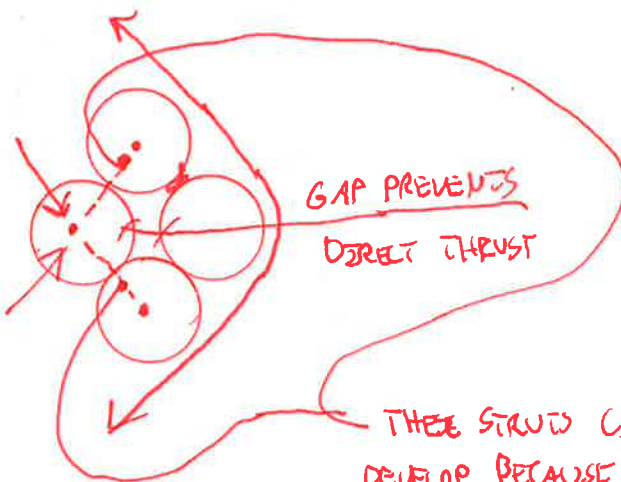
THESE STRAPS CAN'T
 DEVELOP BECAUSE THEY
 REQUIRE BENDING
 IN STRAP
